Addendum No.: 4

Date of Addendum: June 17, 2020

Willard Diloreto Parking Garage
Paul Manafort Sr. Drive
New Britain, CT
CF – RC – 402

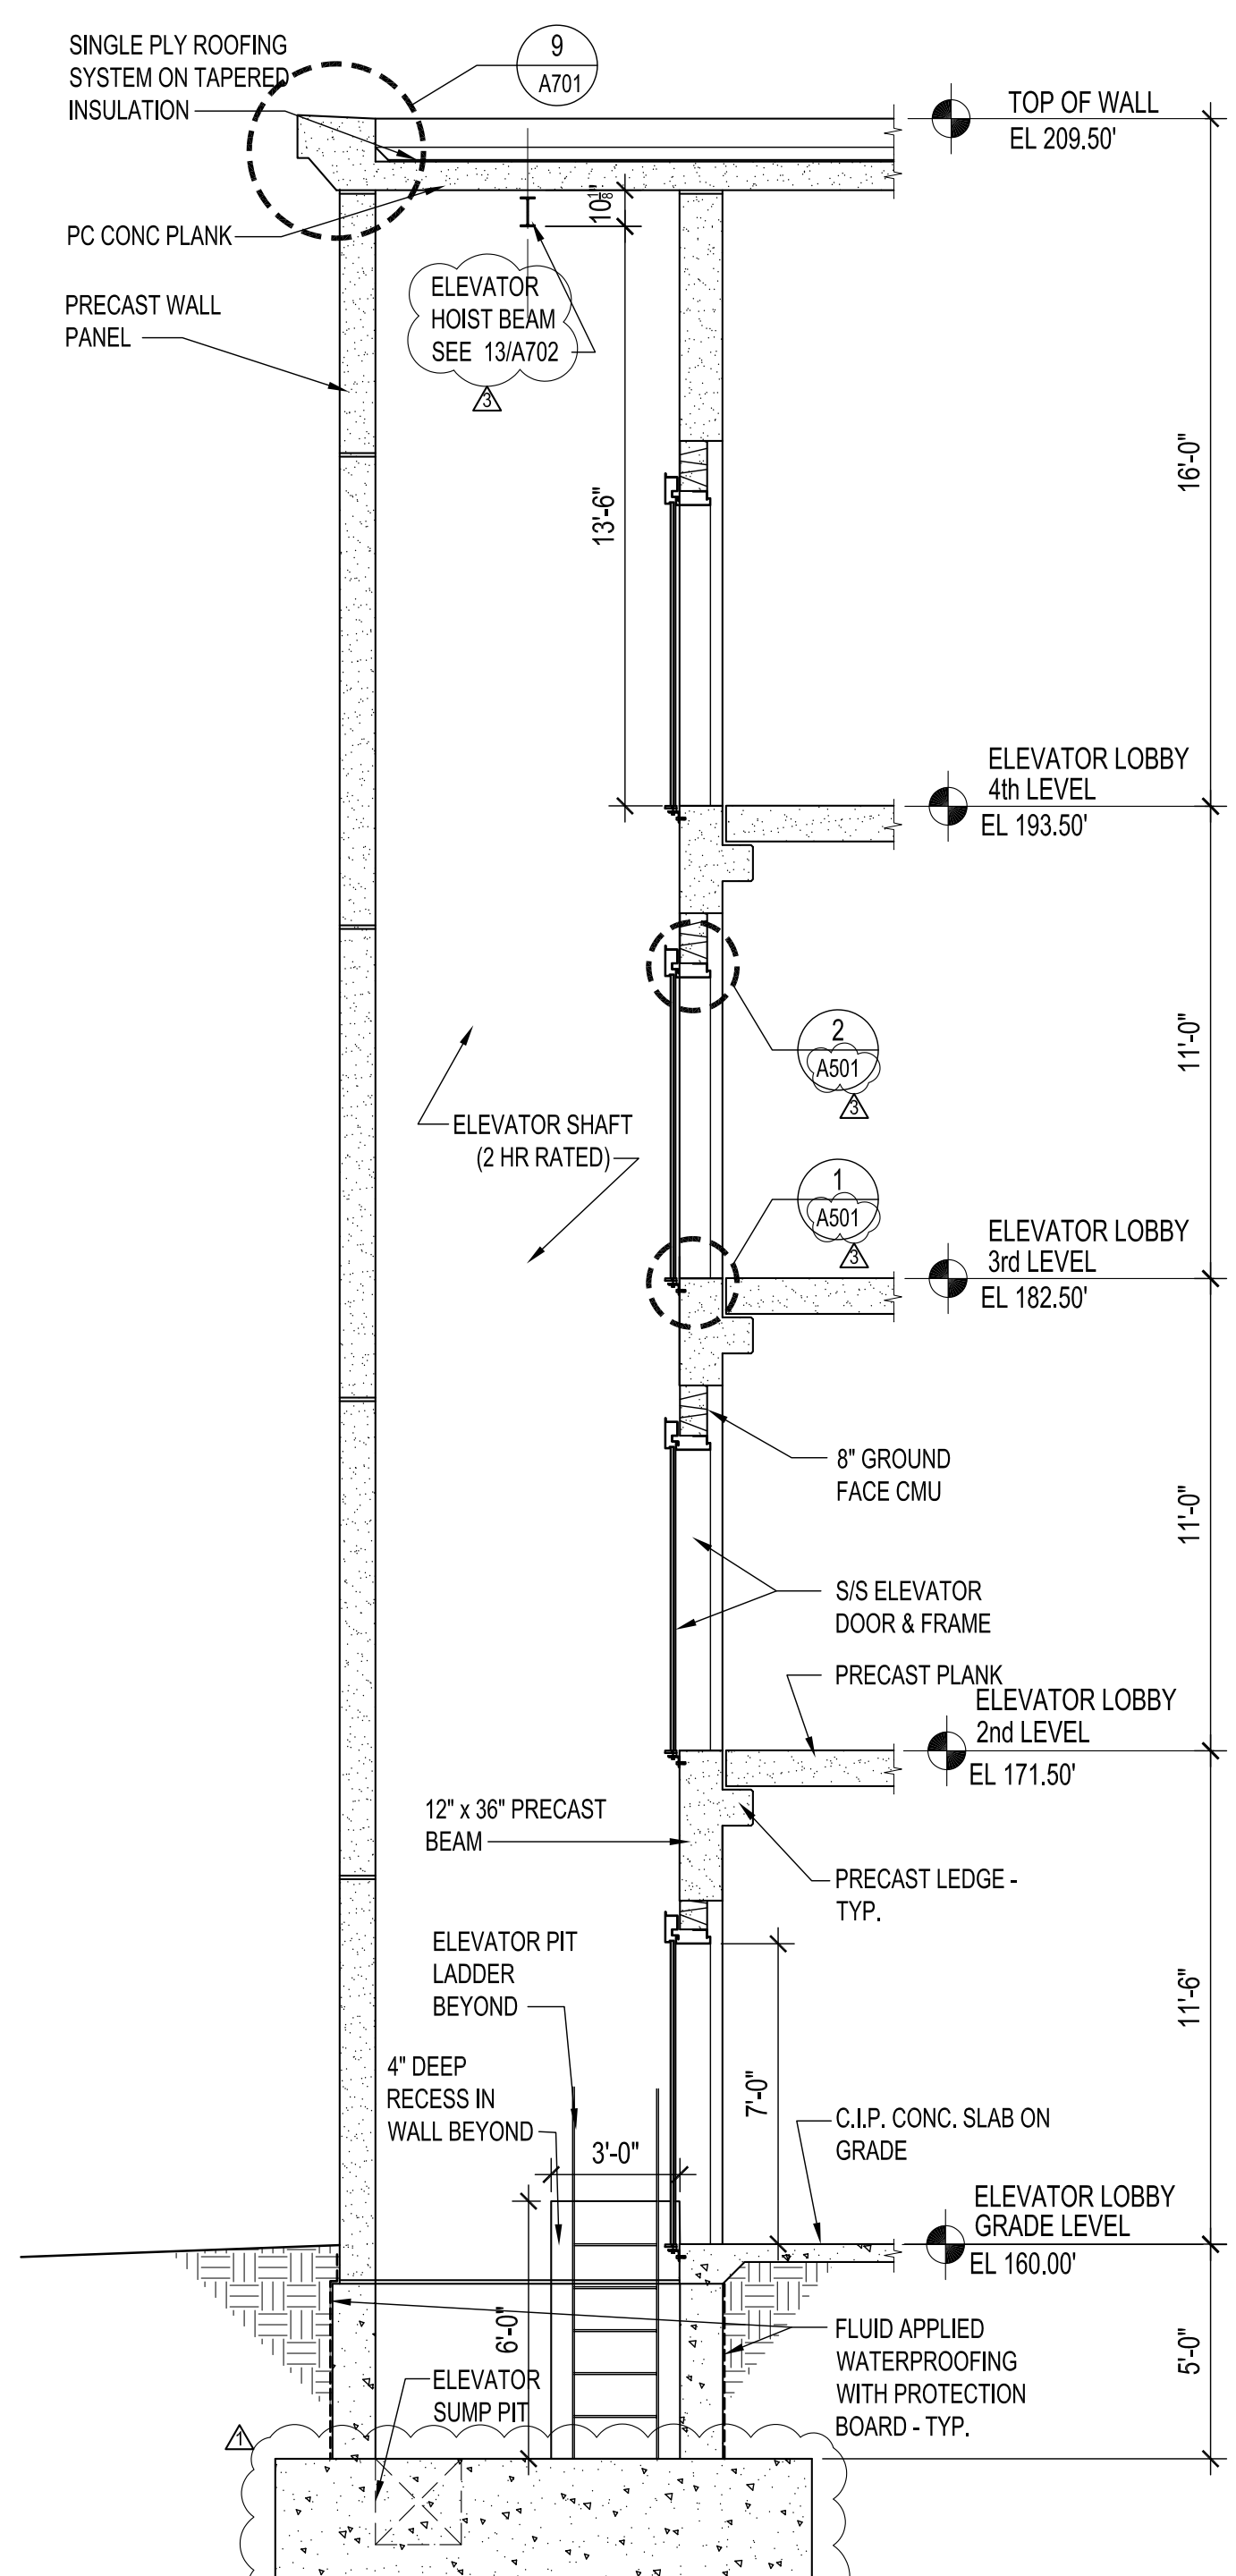
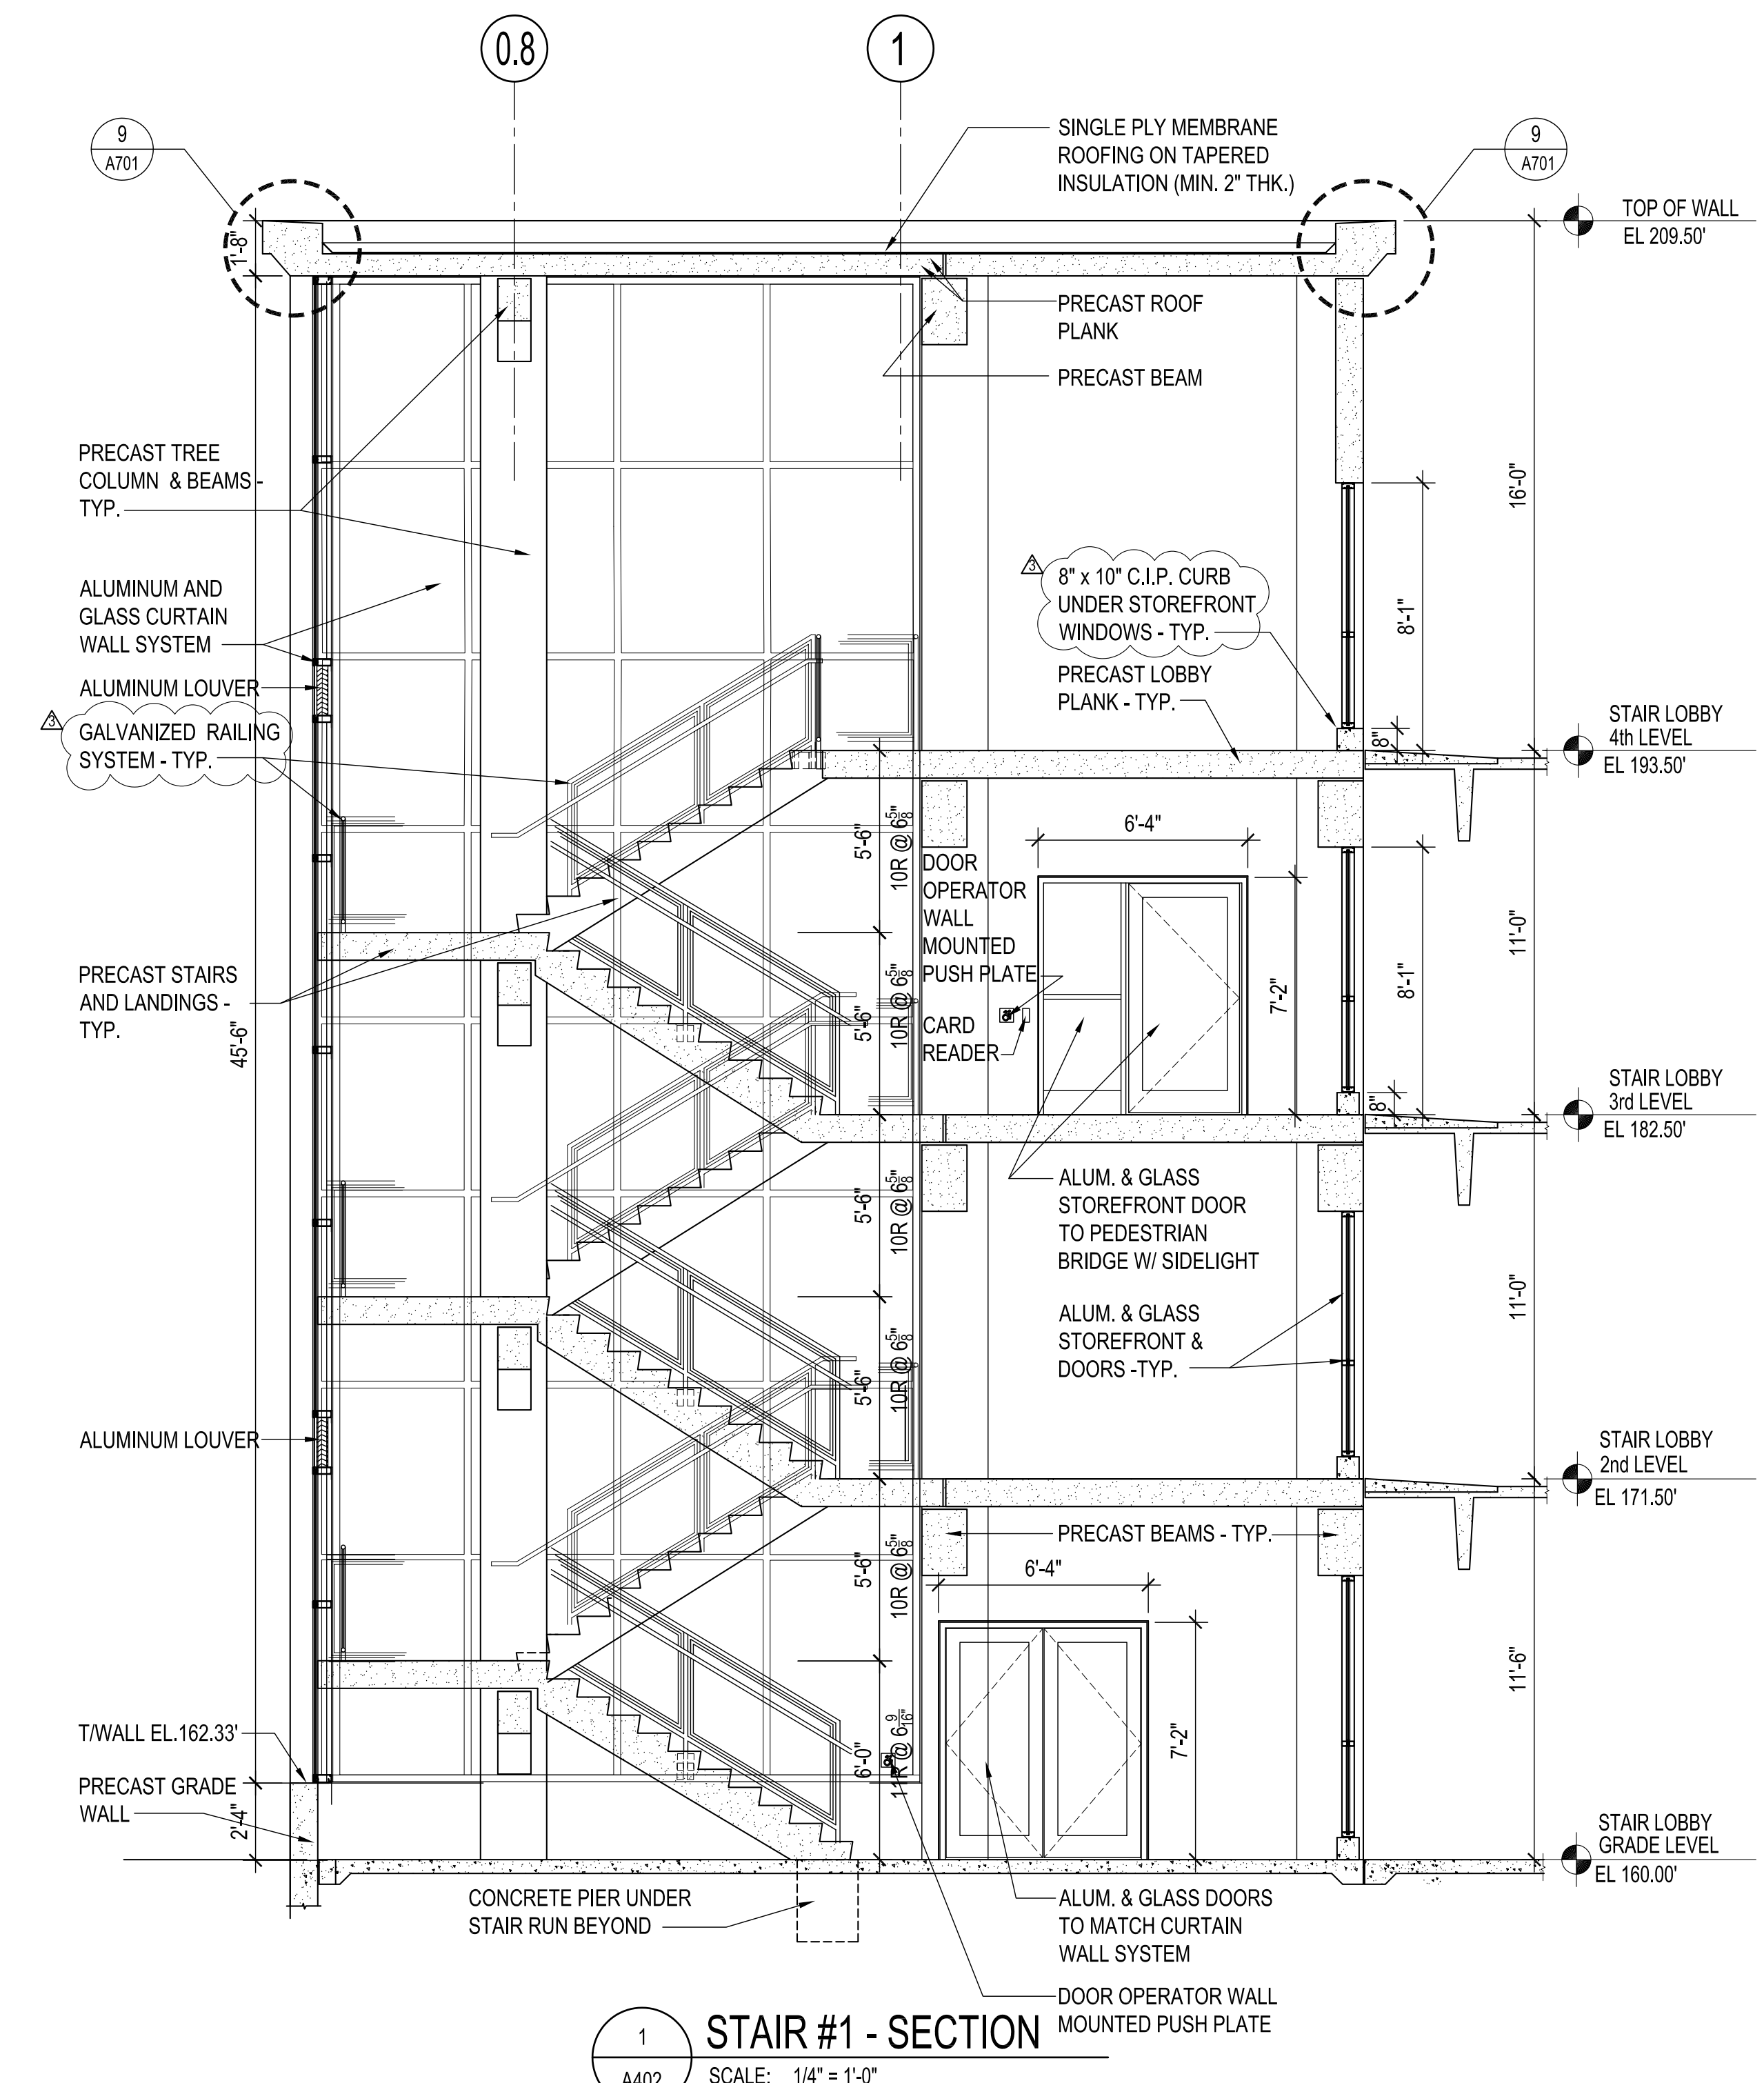
Question: Sheet A-503, Finish Legend - states that the stair guardrails are to be galvanized mesh screen with galvanized frames. The floor plans for each stairwell show them as galvanized also, the cross sections (A402, A405, & A407) have notes to paint the railing system. Is the galvanized guard railing (frame and mesh) painted in the field?

Answer: See revised stair section drawings A402, A405, A406 and A407. All railing systems are to be galvanized and not painted.
